PROJECT: Thoreau Elementary School Interior Renovations
PRA PROJECT NUMBER: 260027-01
DATE: 20 APRIL 2026

SUBJECT: **ADDENDUM NO. 01**

Thoreau Elementary School Interior Renovations

TRUE NORTH PLAN NORTH
PARTIAL FIRST FLOOR LIGHTING PLAN
 1/8" = 1'-0"

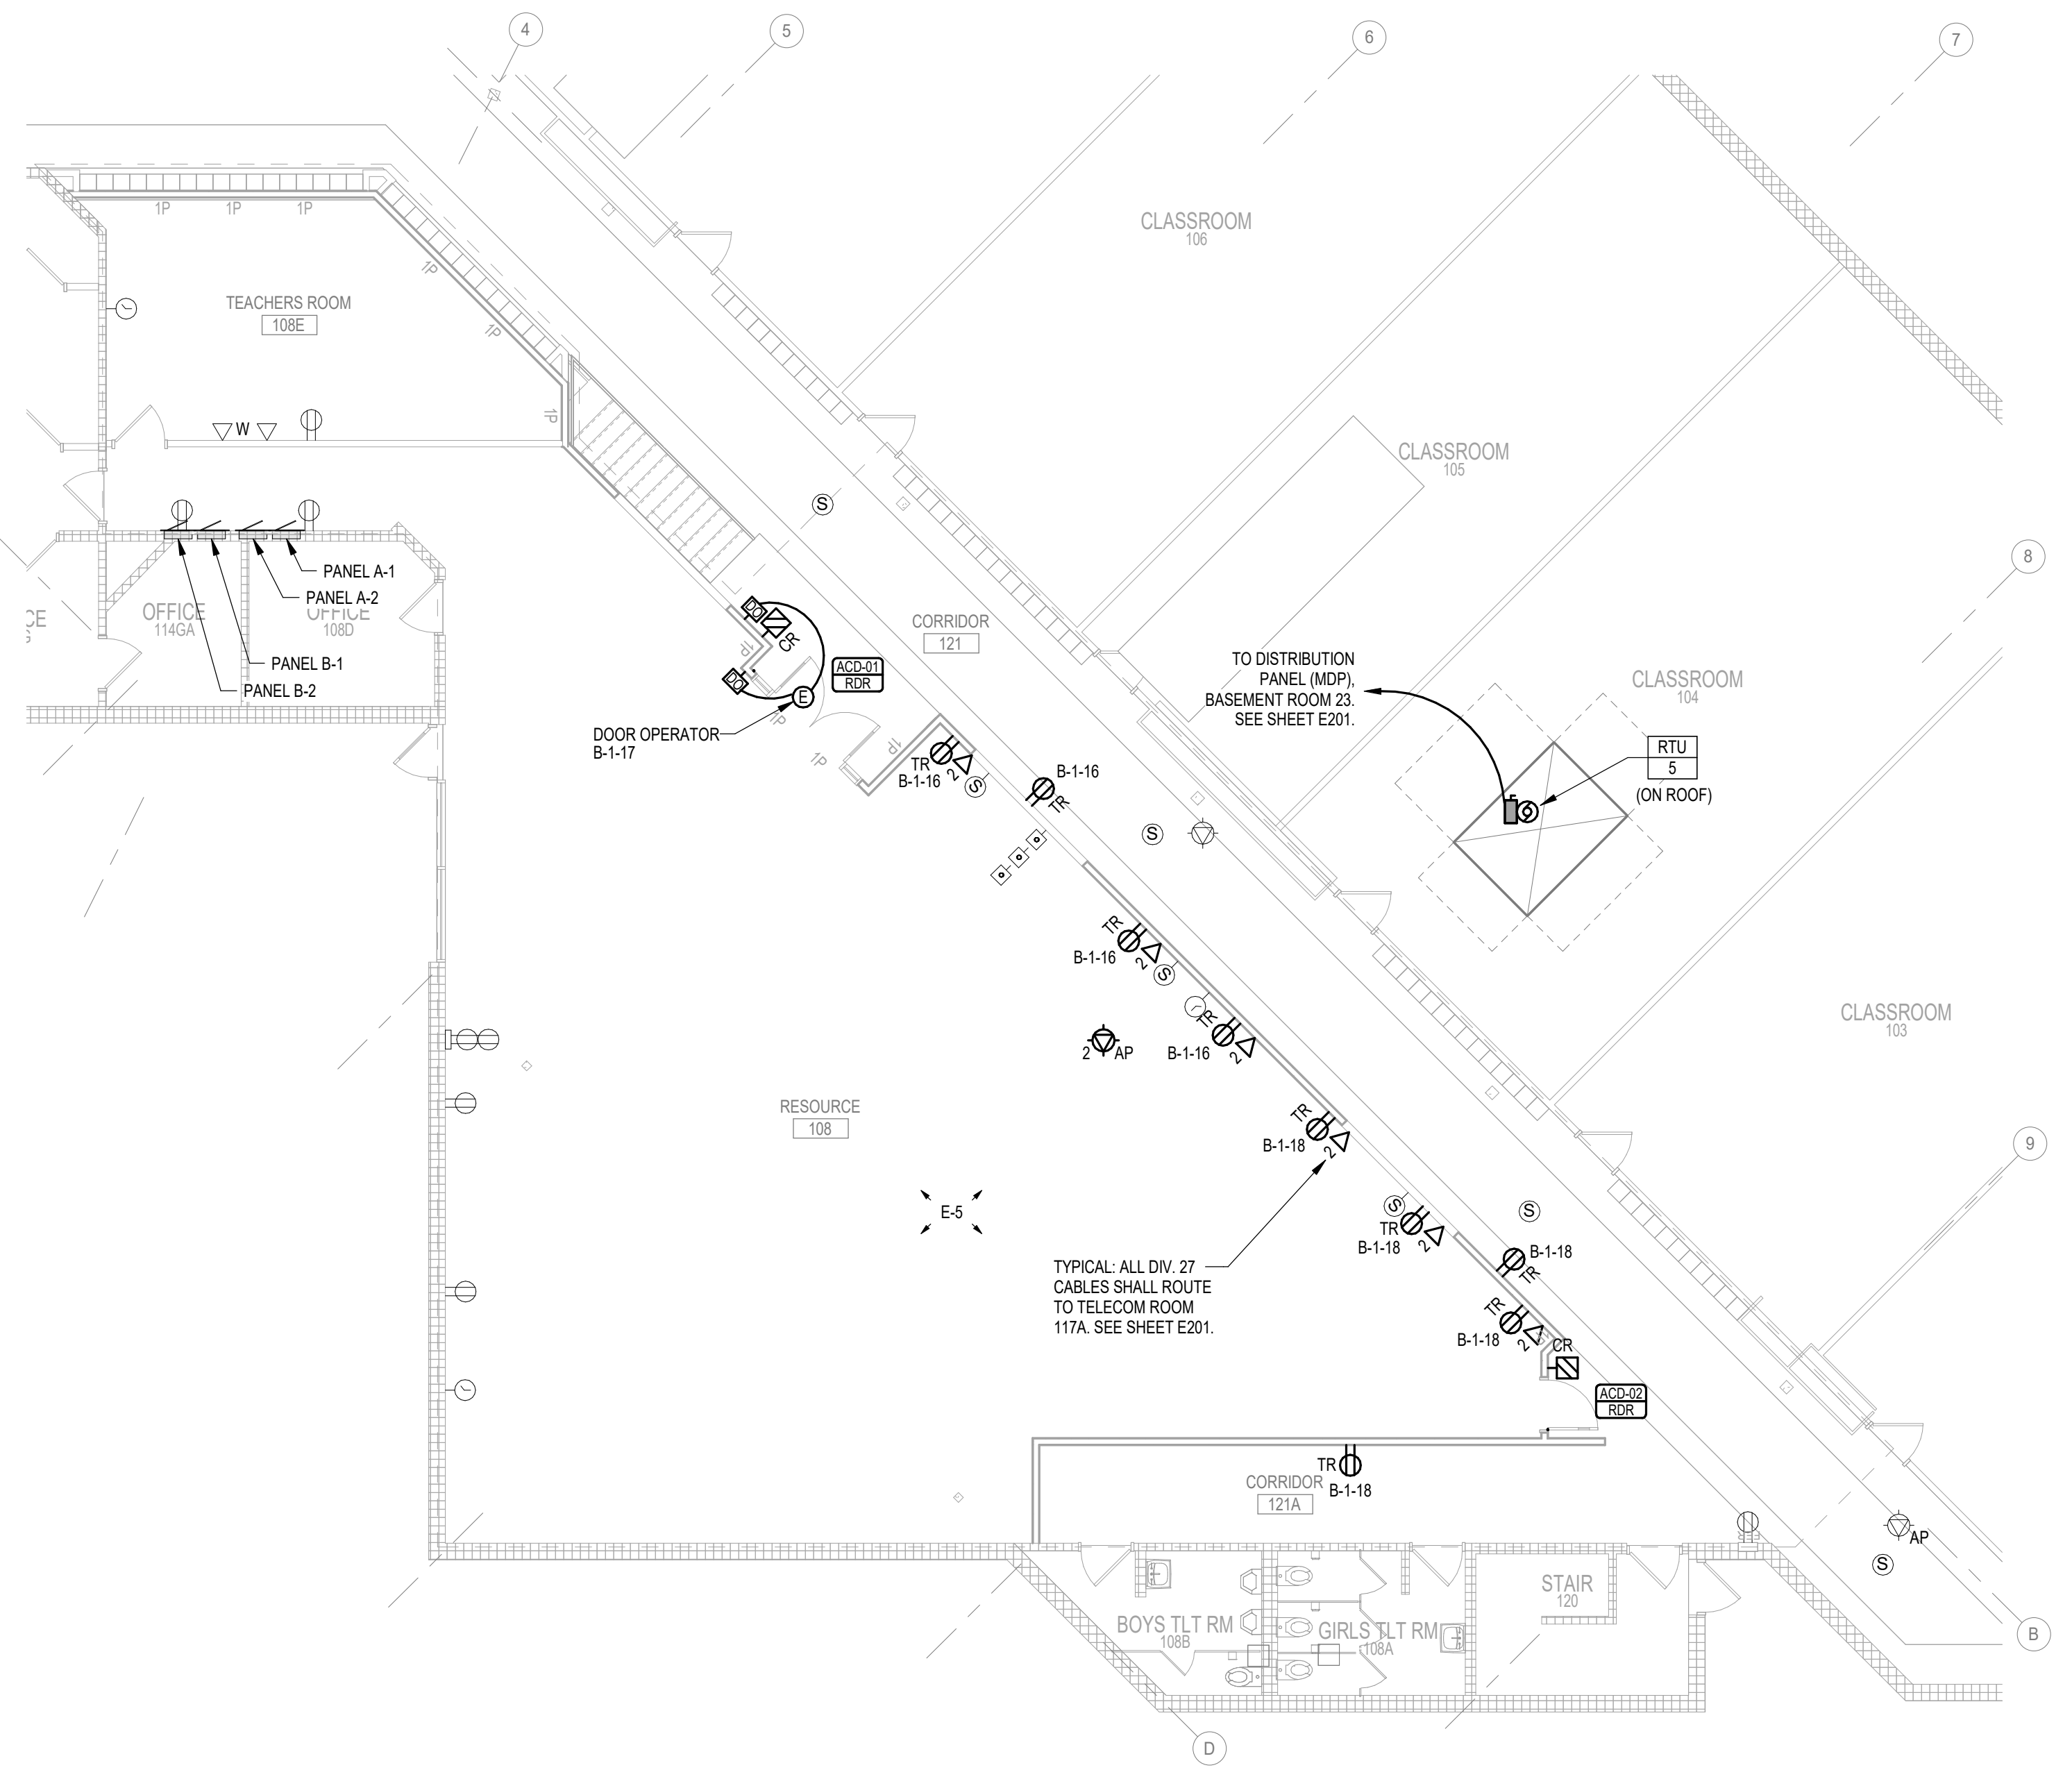
A. E200 – PARTIAL ELECTRICAL PLANS

1. REVISE: Revise plans as shown on attached revised sheet E200.
